PROJECT: 2026 Elevator Replacement Project
Scottish Corners Elementary School

ADDENDUM 2

Revision to **Construction Documents**

ISSUE DATE: February 26, 2026

G101

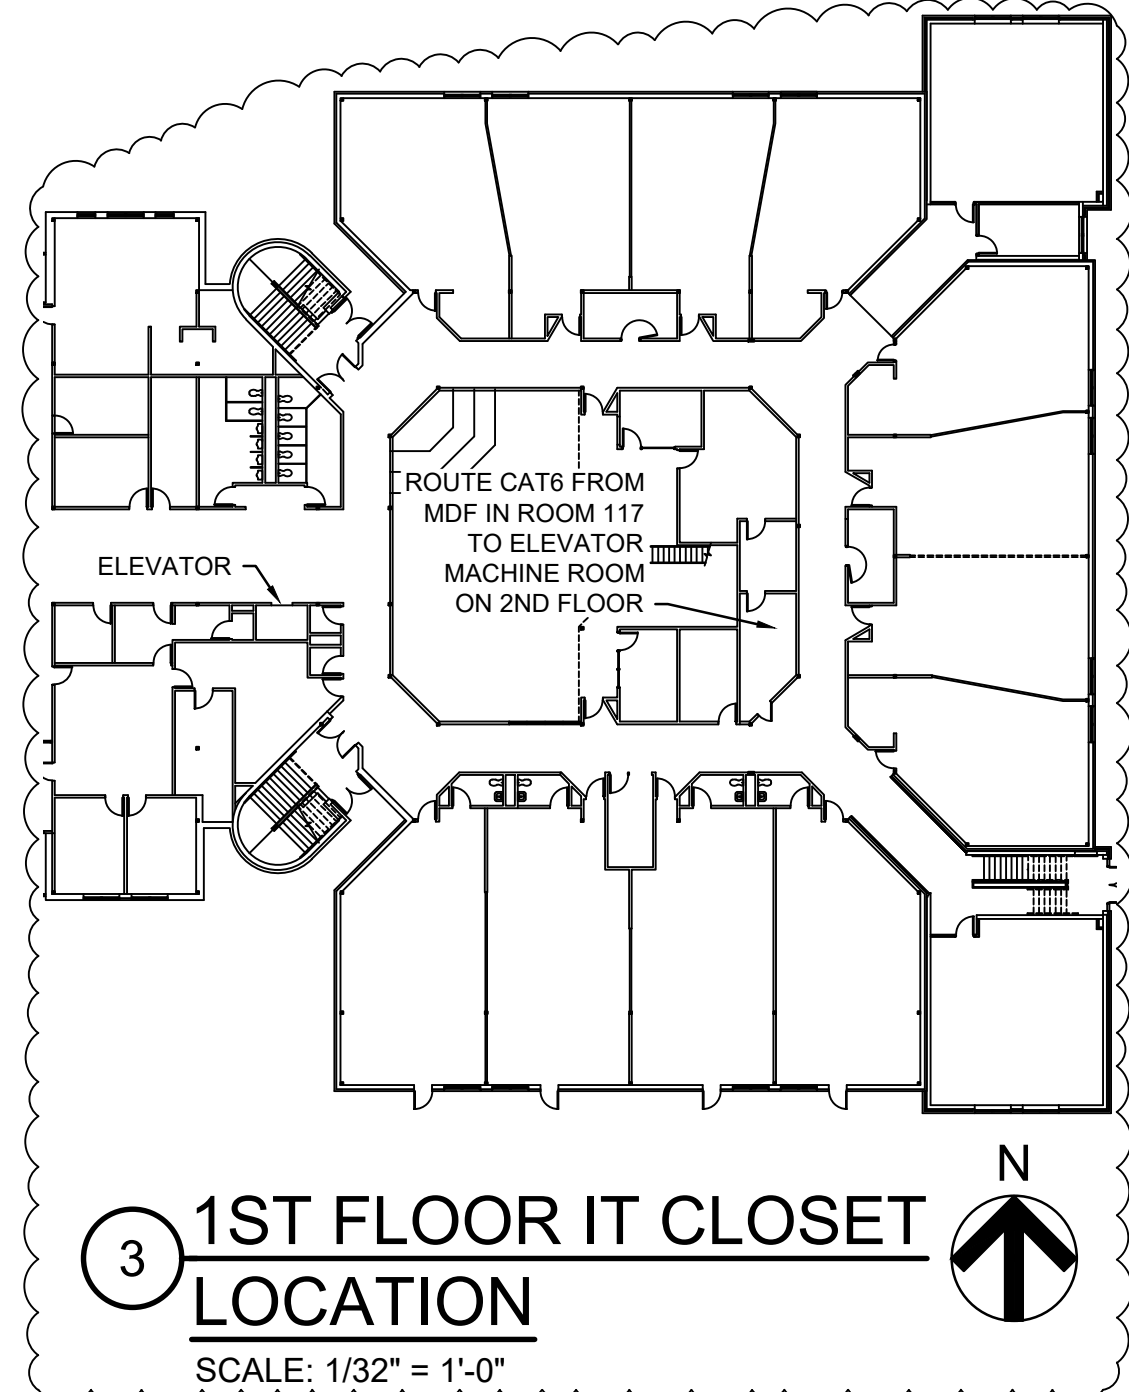
a. **Sheet G101**

- i. Hoistway door frames to be retained and repainted.
